Cowal Gold Underground Development Groundwater Assessment Peer Review

NSW Department of Planning
Industry and Environment

20 May 2021
(Final Review)

Figure 2 - Bland Creek Palaeochannel Borefield model (after Coffey 2020b)

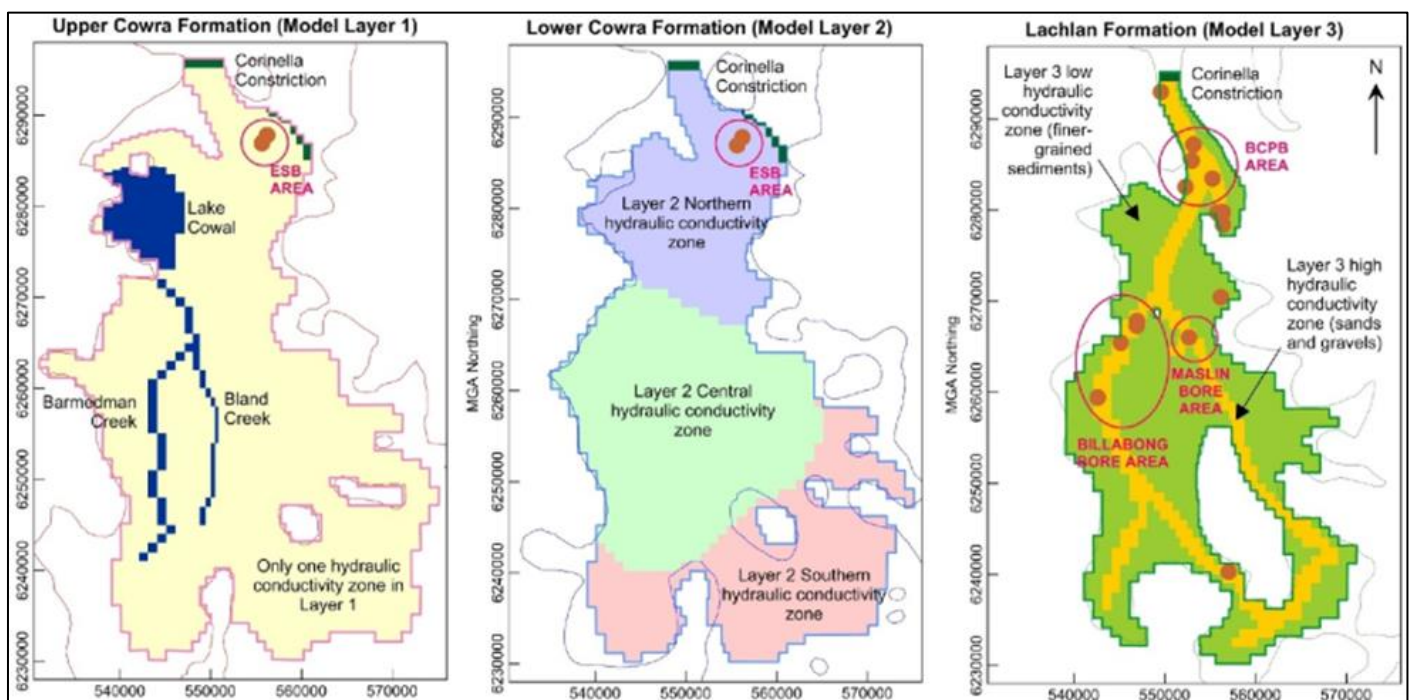
There are inconsistencies between the borefields model and the mine site model in the treatment of the Upper Cowra Formation at the mine site, which is discussed further in section 2.4. These issues were adequately addressed by the response to submissions (eg. Addendum 1, item 7; EMM 2021b). In principle, the significant drawdown in the Upper Cowra Formation at the CGO mine site should ideally be included in the borefields model, even though it is predicted not to extend beyond the mine lease area. Despite the inconsistencies, the borefields model is assessed as fit for purpose in and of itself, based on the following findings.

However, there are inconsistencies between the two models in relation to the Upper Cowra unit having a more limited westwards extent over the CGO site area in the borefields model, and it having quite different values for its key properties (horizontal hydraulic conductivity Kh, and unconfined specific yield Sy), as shown in Table 1.

A related parameter inconsistency issue is that the Upper Cowra Kh value in the mine site model is 50 times smaller than the Kh value in the borefields model, while the Sy value is 5 times larger in the mine site model than the borefields model. This parameter inconsistency means that a cumulative impact assessment is problematic.

Notwithstanding the inconsistency issue between the two models, the borefield model design, performance and predictions are assessed as fit for purpose. Given that a range of corrective actions were recommended for the mine site model, the initial review suggested that any adjustments of parameter values, such as may be warranted to rationalise parameter values and allow for an assessment of cumulative impacts (borefields plus mining) as further discussed below, should probably be applied to the mine site model, but that is entirely up to the proponent and their consultant. In any event, these issues were adequately addressed in the response to submissions reports (EMM 2021a, pp.79-84, and EMM 2021b, item 7).

Figure 3 - CGO mine site conceptual model (after Coffey 2020a)

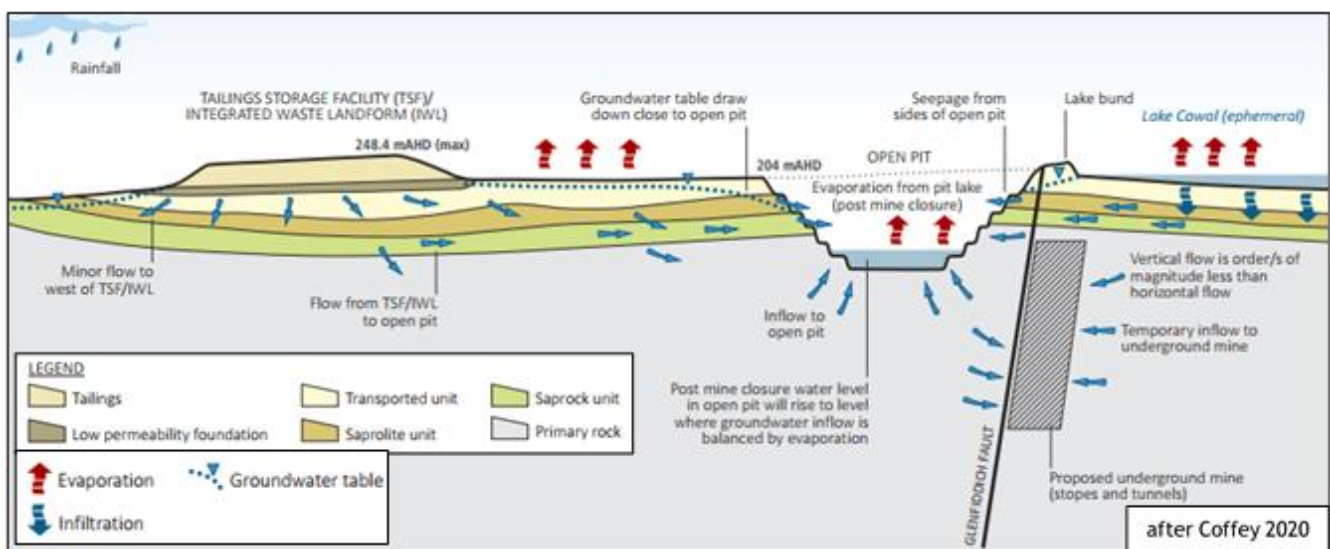
The mine site model has a sound and mature conceptual basis (Figure 3). The mine site model shows a good history match calibration to the data record 2004-2020, and aquifer parameters that are adequately benchmarked to what amounts to a very wide range of parameter values, although there are issues with the model water balance (discussed further below). This suggests that the model may be affected by model non-uniqueness (the principle that multiple combinations of parameters may be equally good at fitting historical measurements). This implies low to medium confidence in the results as presented, as the uncertainty assessment conducted is somewhat limited. A comprehensive uncertainty assessment would improve confidence.

Figure 4 - pit dewatering and rainfall (after Coffey 2020a, Figure 8-18)

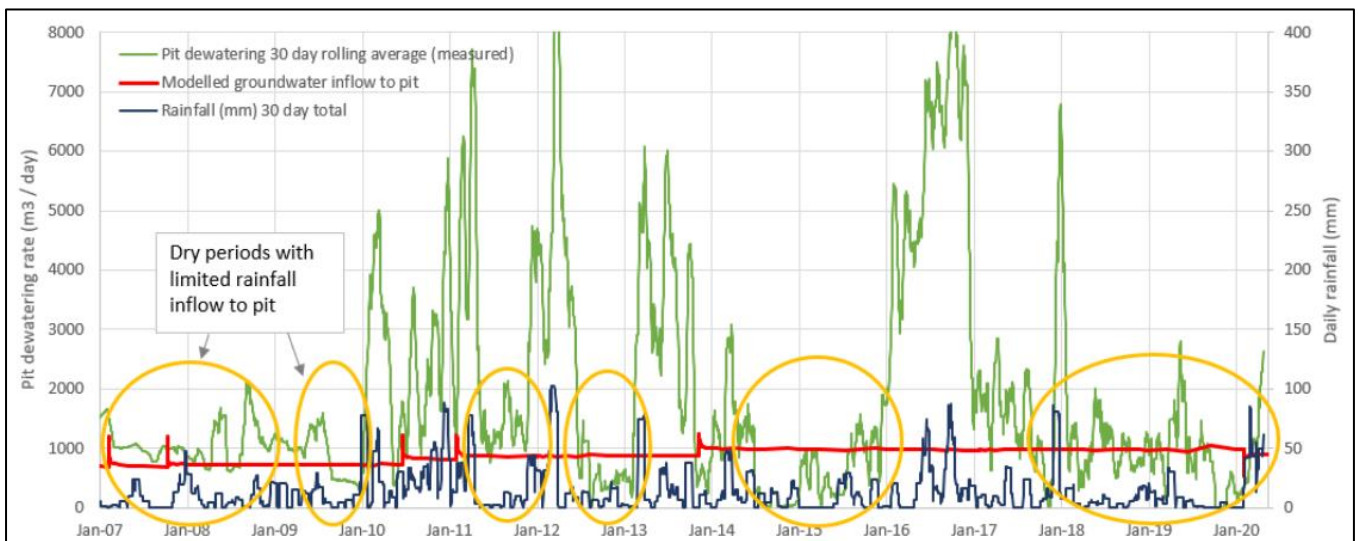
The modelled open pit ‘groundwater inflow’ rates are typically around 0.8-1.0 ML/day (red line in Figure 4, next page), and are adequately consistent with the reported volumes during low rainfall periods (yellow shapes in Figure 4), such as 2018-2020. The report (Coffey 2020a) shows that the recorded pit dewatering volumes are quite variable (green line in Figure 4), ranging from around 1 ML/day or less during low rainfall periods, up to 8 ML/day during very wet periods (eg. 2010-2012, 2014, 2016).

The report suggests erroneously that recorded pit dewatering does not correlate well with rainfall, as it is clear from Figure 4 that pit dewatering historically increased greatly during wet periods, typically by a factor of 4 or 5 times, and sometimes up to 8 times. The response to submissions (EMM 2021b, item 4) provides a reasoned clarification that groundwater inflows are less variable than pit dewatering rates, and it is inflows that do not correlate strongly with rainfall.

The report does not explain whether the modelled 'groundwater inflow to the pit' (Figure 4 above) represents some or all of those dewatering features, or what proportion is formed by rainfall runoff during high rainfall periods. Related descriptions such as at sections 8.3 and 10.3 of Coffey (2020a) suggest somewhat unusual parameter adjustment methods, but the explanations are largely incomprehensible and warrant a rewrite.

As requested at the initial review stage, the proponent subsequently provided further detail on the components of 'groundwater inflow to the pit' in the response to submissions reports (EMM 2021a, section 4.1.1), and also in Addendum 1 (EMM 2021b, item 3) and Addendum 2 (EMM 2021c, sections 4.1 and 4.9.6), which also provided at item 4 a cogent explanation as why it is acceptable for the model to be benchmarked to 'groundwater inflows' only during dry periods.
